Product Change Notification

Bourns® Model SRN8040 Semi-Shielded Power Inductor Series Change to Packaging Specification, Minimum Order Quantity and Multiple Ordering Quantities

Figure 1 - Current Carrier Specification

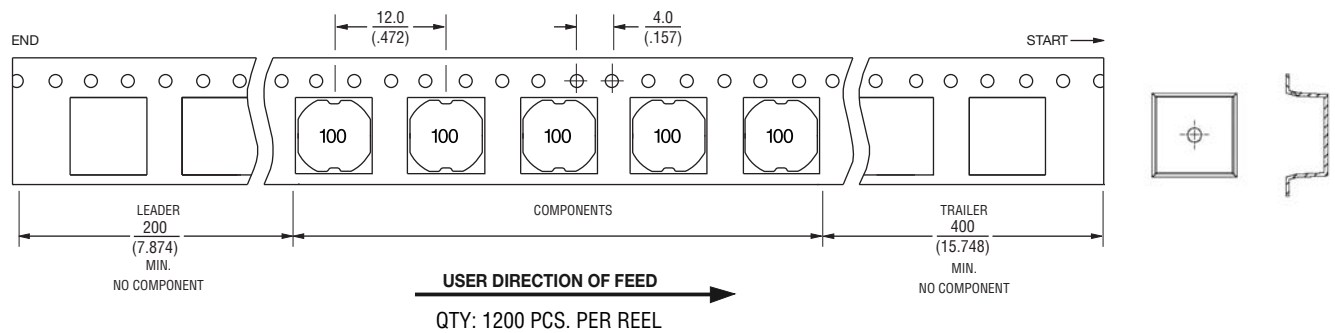
The packaging specification of the tape and reel carrier of the Model SRN8040 has been redesigned with embossment on the bottom and sides to provide shock absorption in order to help protect the inductor during shipping and handling. Along with this change, the tape leader, trailer and the number of inductors packaged per reel has been modified. Figures 1 and 2 highlight these changes. The MOQ and MULT ordering quantities of the Model SRN8040 Series have changed from 1200 pcs to 1000 pcs.
